**CITY OF MERIDIAN
FINDINGS OF FACT, CONCLUSIONS OF LAW
AND DECISION & ORDER**

Case No(s). H-2024-0073

COMMUNITY DEVELOPMENT DEPARTMENT REPORT

SUBJECT: H-2024-0073
PAW Subdivision

D. Preliminary Plat (date: 9/22/2021)

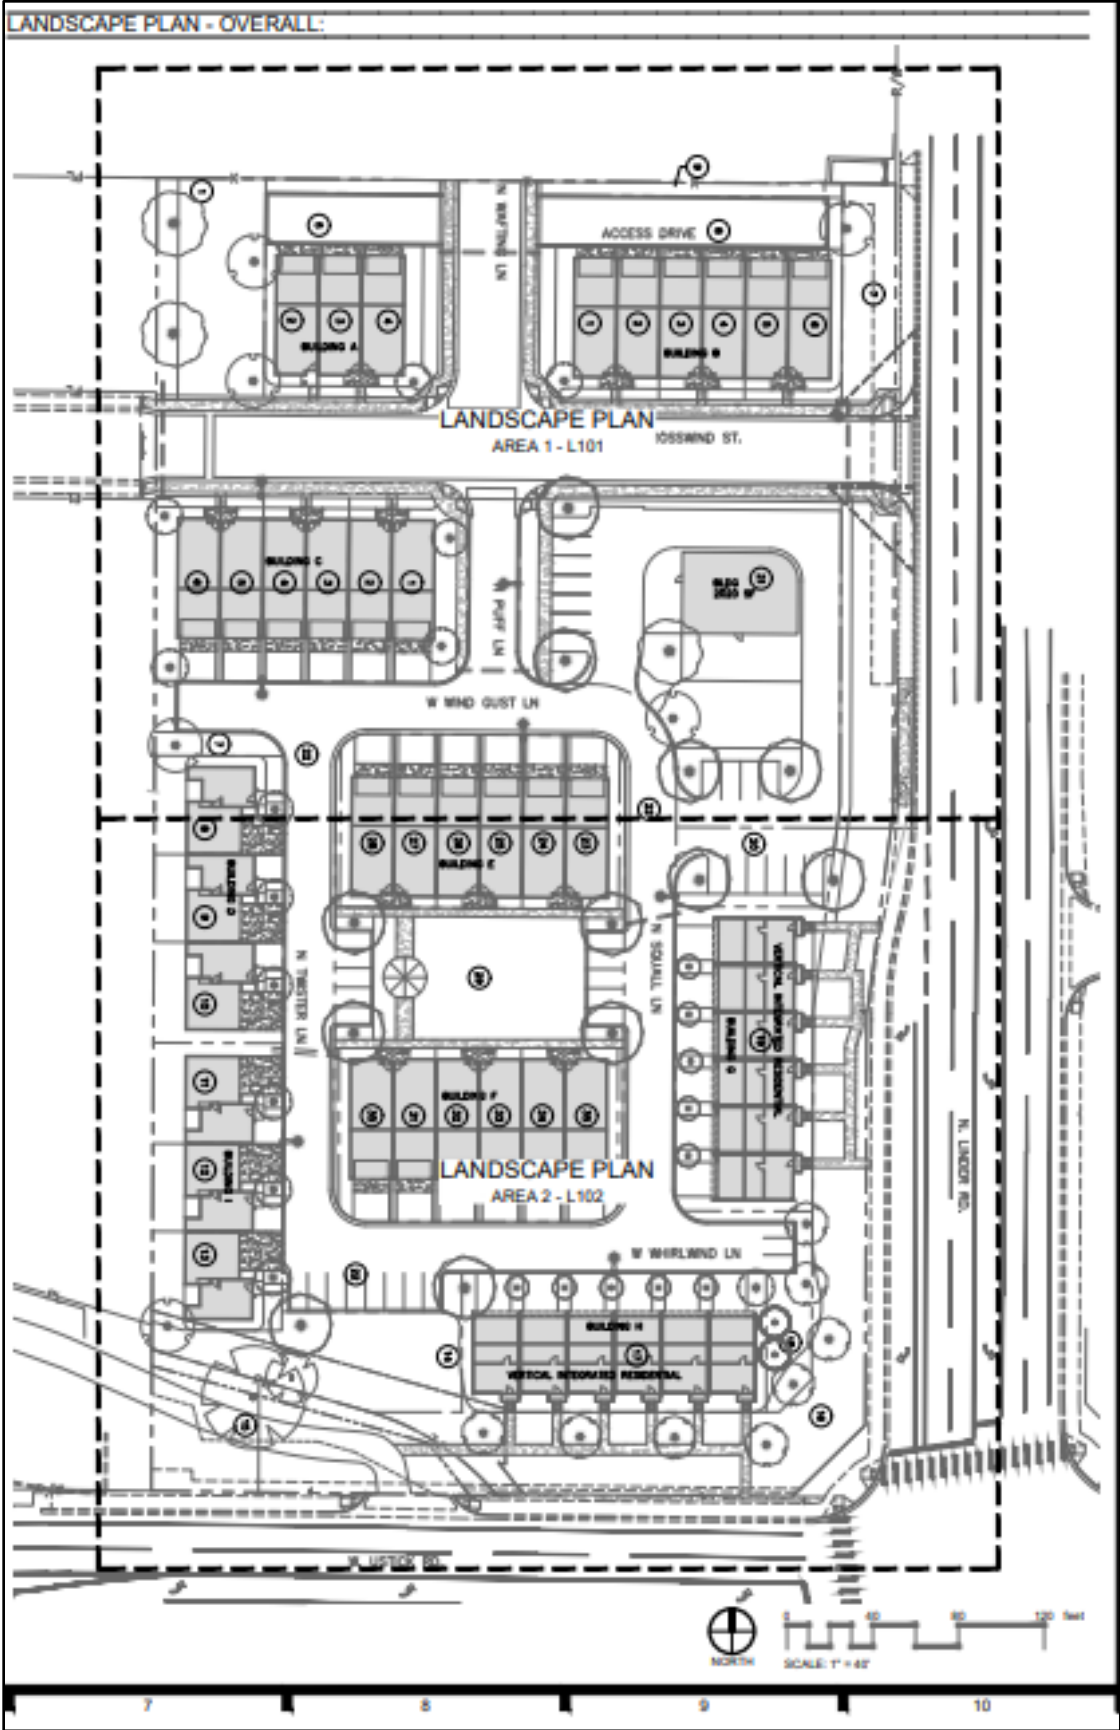
13. The preliminary plat dated 3/04/2025, shall be revised as follows:
 - a. Per UDC 11-3B-7, all arterial street buffers shall be on a common lot or on a permanent dedicated buffer, maintained by the property owner or business owners' association.

E. Landscape Plan (date: 11/30/2022)

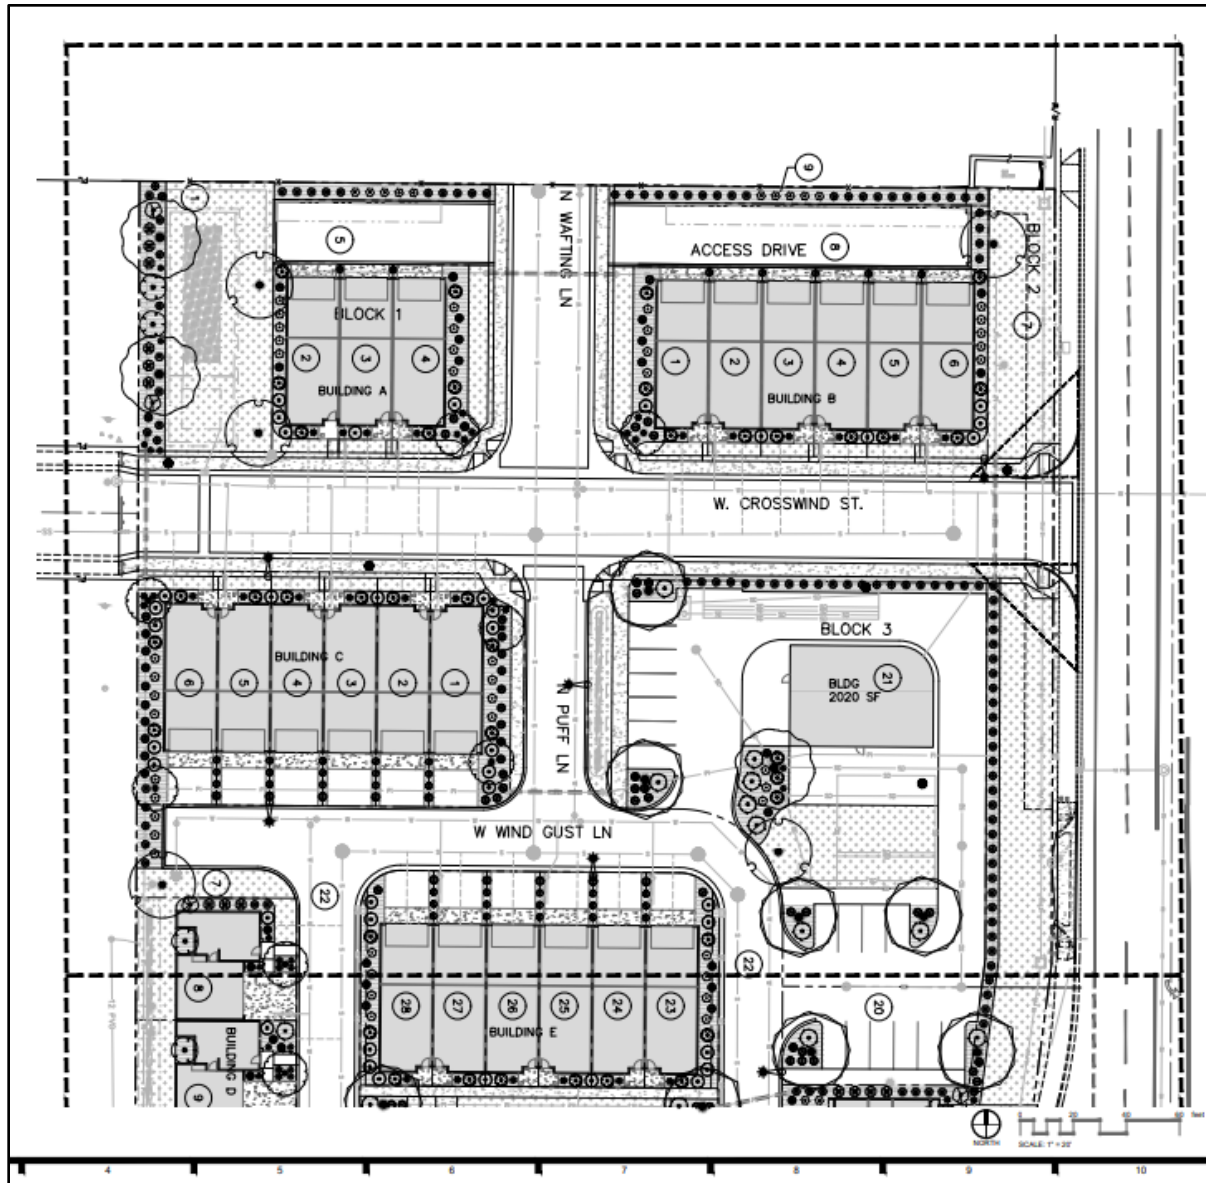
However, it does not appear either landscape buffer meets the minimum landscaping standards of at least one tree per every thirty-five (35) linear feet. as there are long sections of arterial buffer without trees. A total of eighteen (18) trees are required along Linder Road. The applicant will need to revise the landscape plan to include the additional trees.

The applicant shall add a mitigation section to the landscape plan for trees meeting the criteria above that are removed.

Per UDC 11-3C-6.G One (1) bicycle parking space shall be provided for every twenty-five (25) proposed vehicle parking spaces or portion thereof, except for single-family residences, two-family duplexes, and townhouses. Based on the thirty-eight (38) parking spaces provided, a total of two (2) bicycle parking spaces is required. The location of the bicycle racks will need to be depicted on the site and landscape plans.

14. The landscape plan dated 3/04/2025, shall be revised as follows:
 - a. Based on the thirty-eight (38) parking spaces provided, a total of two (2) bicycle parking spaces is required. The location of the bicycle racks will need to be depicted on the site and landscape plans. An example of the bicycle rack will be required to be submitted with the CZC for review and approval.

- b. The landscape plan shall show any proposed fencing for the development with a detail of the fencing being proposed.
 - c. The landscape plan shall provide the minimum density of one (1) tree per thirty-five (35) linear feet is required for street buffers per UDC 11-3B-7.

- d. Apply the 10-foot landscape buffer along W. Crosswind Street in the location of the commercial pad.
 - e. Per UDC 11-3B-10, a mitigation section shall be added to the landscape plan for trees that are removed from the site that are four-inch caliper or greater.
